AGENDA
PLANNING AND ZONING COMMISSION MEETING
CITY OF CREVE COEUR, MISSOURI
MONDAY, OCTOBER 17, 2011
7:00 PM

Application #11-027 for rezoning from “C” Single-Family Residential to “GC” General Commercial and Site Development Plan approval for the property located at 11122 Olive Boulevard for use as a Goddard School for Early Childhood Development.

**APPLICATION TO PLANNING AND ZONING COMMISSION
#11-027 FOR REZONING FROM "C" SINGLE-FAMILY RESIDENTIAL TO "GC"
GENERAL COMMERCIAL AND SITE DEVELOPMENT PLAN APPROVAL FOR
THE PROPERTY LOCATED AT 11122 OLIVE BOULEVARD**

ZONING EXHIBIT

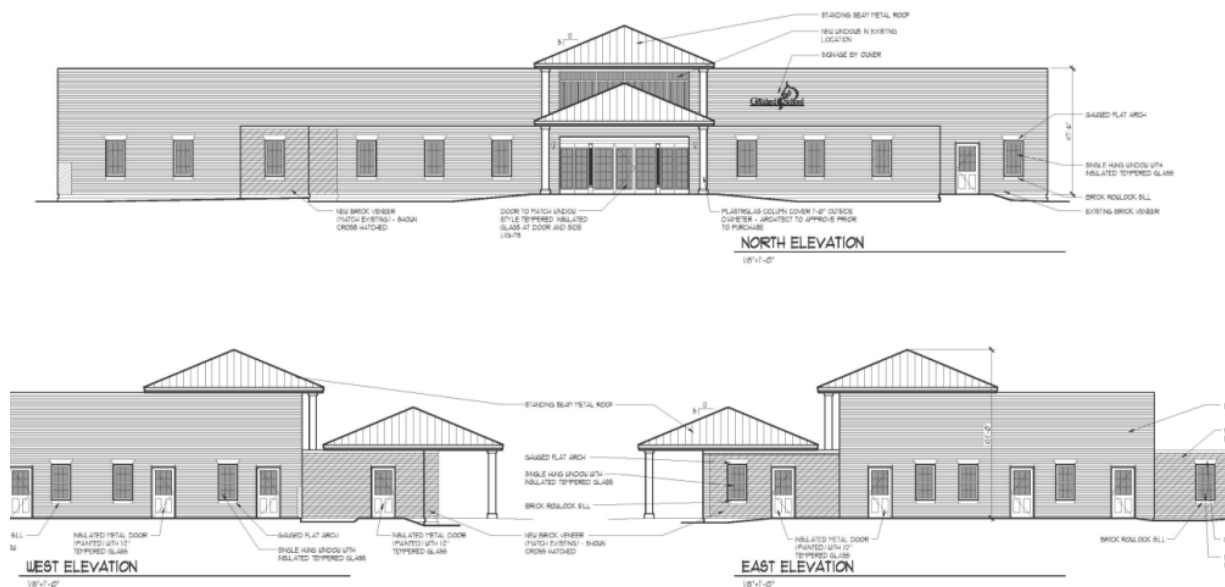
The applicant is proposing to use the existing structure, and will add a new addition to the front and rear of the building in a brick veneer that will match the existing brick, as well as create a new entry, satisfying the Design Guideline recommendations for building design, by working with, rather than attempting to mask the original design style of the building. A close up of the north, east, and west elevations are below:

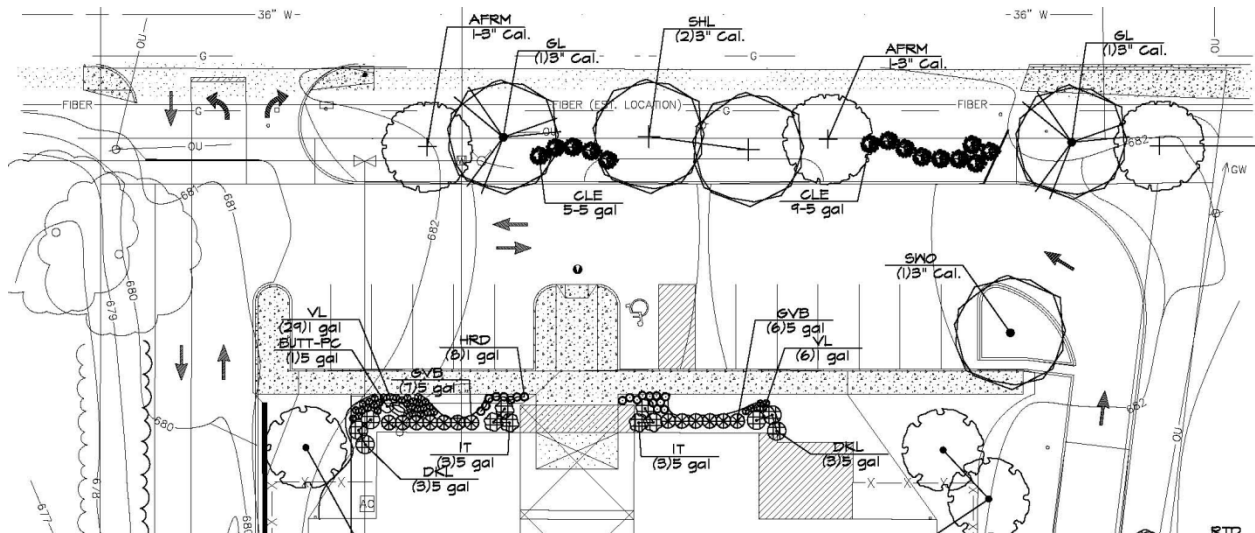
As mentioned earlier, the Comprehensive Plan calls for a “green line” park along Olive Boulevard. Below is a close up of the proposed landscaping for the front of the building and along Olive Boulevard:

The proposed front yard design includes only minimal planting and single row of bushes to fill in the gaps between the trees. Further, while the number of street trees provided meets with the City’s requirement for street trees, they are “bunched up for a more natural look”, as opposed to the required linear spacing of 1 tree for every 30 feet, per the discussion for Zoning Code review below. Whether or not the overall design provides for the lushness in character to meet with the “green line” park objective is up to the Commission Members to decide. However, it is Staff opinion that by only minimally meeting with the Code requirements, the design falls short of the lush “green line” park setting called for in the Comprehensive Plan and Design Guidelines along Olive Boulevard. Overall, the design lacks a year round depth, variation in height, an overall organizing theme, and a mix of vegetation and hardscape. The area is small and therefore it is important to get the most out of the design. Staff requires that the Commission members provide direction on the level of landscape design that they believe would better satisfy the Comprehensive Plan and Design Guidelines. However, in order to facilitate the project moving forward, Staff has included a condition that landscaping shall be revised, based the discussion with the

- b. The Site Development Plans shall be revised to meet with the intent of the "green line" park along the Olive Boulevard frontage identified by the City of Creve Coeur Comprehensive Plan and Design Guidelines, subject to the review and approval of the Planning Commission upon the recommendation of the Director of Community Development. The Director shall not forward a recommendation without the written acceptance of the MoDOT.
